November 2012 Environmental Update for SLEMA Board

Zhong Liu
November 30, 2012

Snap Lake North Pile and Sumps

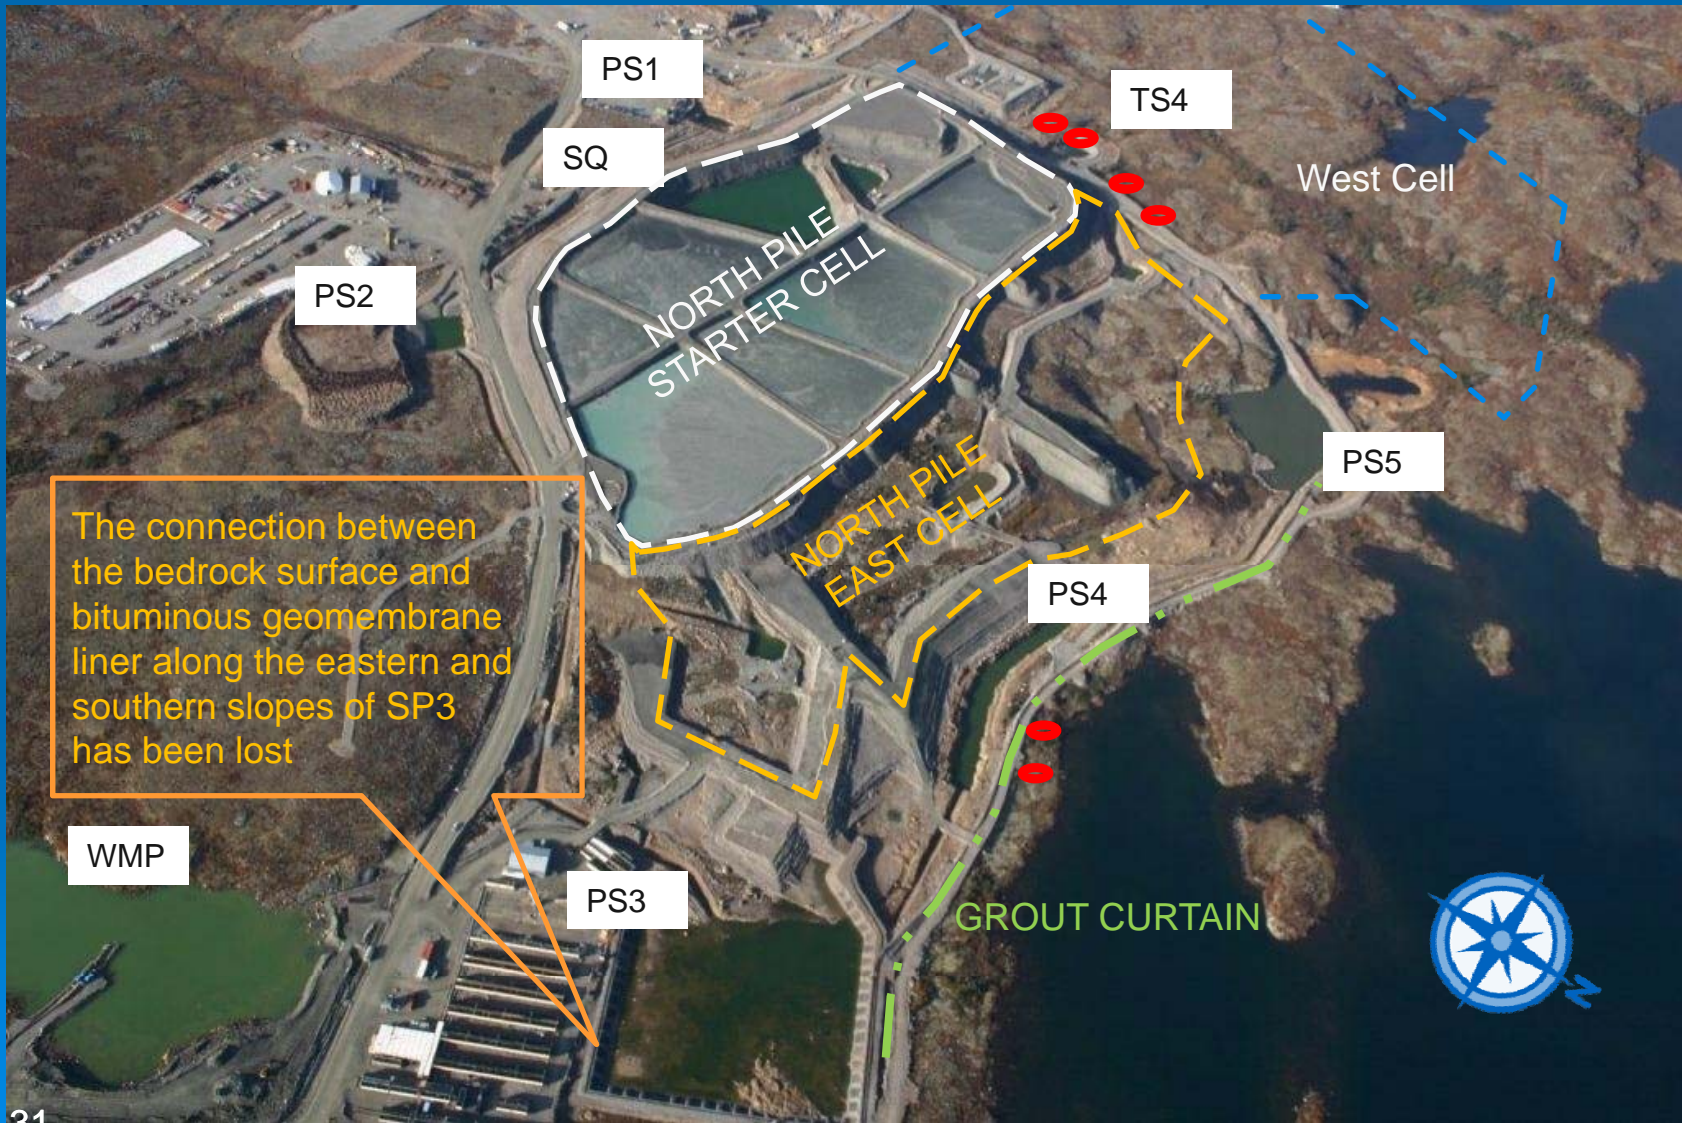
- The connection between the bedrock surface and bituminous geomembrane liner along the eastern and southern slopes of SP3 has been lost as a result of water flows below the sump by-passing relieve valve flaps near the bedrock contact interface. Replacement of the geomembrane liner bedding layer has been compromised as a result from the flow of water into SP3. The liner bedding system is to be evaluated, and repaired as necessary, at the time of liner replacement. Once the liner and liner bedding system have been re-established, granular fills are to be placed over the entire surface of the geomembrane liner to provide confinement as previously recommended by Golder
- De Beers Response – under review

- Inquiry e-mail about SP3 sent to De Beers on November 20, 2012
 - “Would you kindly explain the implications of the lost connection between the bedrock surface and bituminous geomembrane liner along the eastern and southern slopes of SP3?”
 - Is there any link between the October 2011 spills and the lost connection?
 - Will it impact the operation of SP3 as designed?”

- Further question from the Environmental Analyst
 - The water level maintained in PS3 (445.757) is still much higher than that in Snap Lake (444.1), is it safe to say “this elevation/volume will ensure no seepage of water occurs”?
- Response from De Beers
 - “Yes, it has been assessed by our water management team and it is well below the elevation in which problems can occur. I double checked on this concern before responding to your original questions”

- “The liner issues described by Golder along the southern and eastern slopes are to be repaired in March 2013
- The liner is compromised by inflow into PS3 and this is NOT related to the spills in October 2011
- Full scale repairs of liner with appropriate ballast, sealing (bentonite) etc is planned for July 2013 for ideal weather conditions and post freshet
- Currently we cannot operate PS3 to design until the above repairs have been done in July 2013. To mitigate any risks of leaks/spills, we will not allow the volume in the sump to exceed 13,000m³ (Elevation 445.757) even during freshet. This elevation/volume will ensure no seepage of water occurs”
